Waterfront - Overlook Walk

Meeting Summary

July 21, 2016
10:00 - 12:30 pm

Revised Concept Design

Figure 1: Previous design (highlighted in black) and proposed design (highlighted in blue)

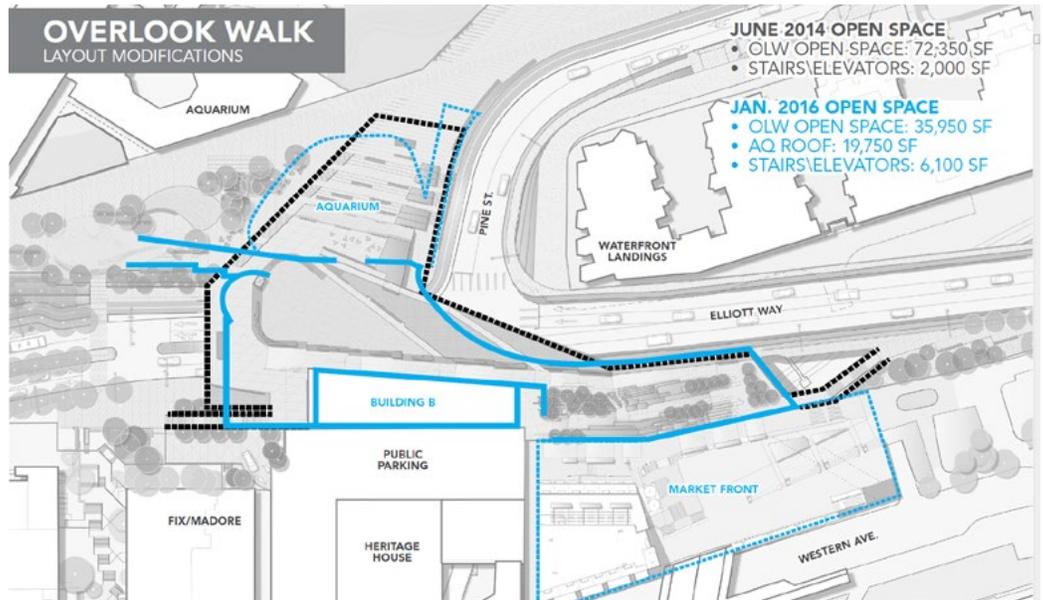
The SDC agreed with the proposed realignment of the stairway from its original design to a new 20-foot wide stairway running parallel to Alaskan Way. The redesign also included a second stairway extending from the Overlook Walk down to the north side of Aquarium Pavilion. Because both stairways will serve as an important route to the Aquarium pavilion, promenade, pier 62/63 and waterfront, the Commission thought it critical to design the landings in a way that will feel welcoming to the public. Commissioners also encouraged the design team to provide a greater amount of program along the wall of the south stairway.

Figure 6: proposed programming - Overlook Walk

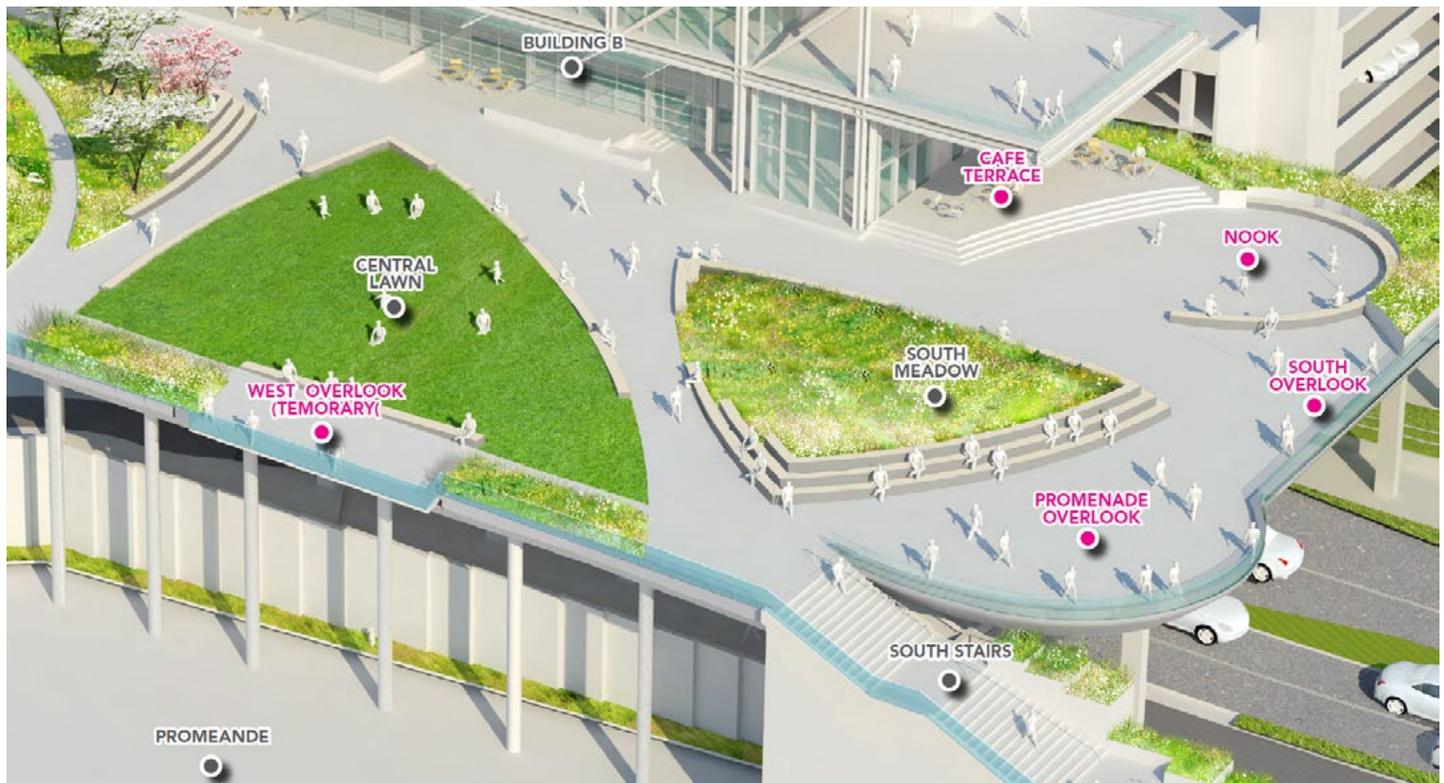
The SDC supported the overall proposed pedestrian circulation - including primary and secondary pathways. Although they appreciated the connections from the proposed market stalls to the south overview over Alaskan Way, Commissioners questioned whether the proposed width and path alignments are adequate to support the number of pedestrians that will be attracted to the Overlook Walk. The Commission recommended the design team reeval-

ate the width of the main pathway leading users from Overlook Walk to the south stairway. The Commission is also concerned with the proposed location of the elevator near the south stairway. They recommended the design team relocate the elevator to a location that is accessible while not interrupting sight lines to the west overlook.

2. Refine the location of the elevator from the Overlook Walk to Aquarium Plaza
3. Increase the width of the connection between the south overlook and south stairway

4. Increase the width of pathways directly leading to the south stairway
5. Verify site lines to the stairway from the project lid over Elliott Way
6. Refine design of the area underneath the lid
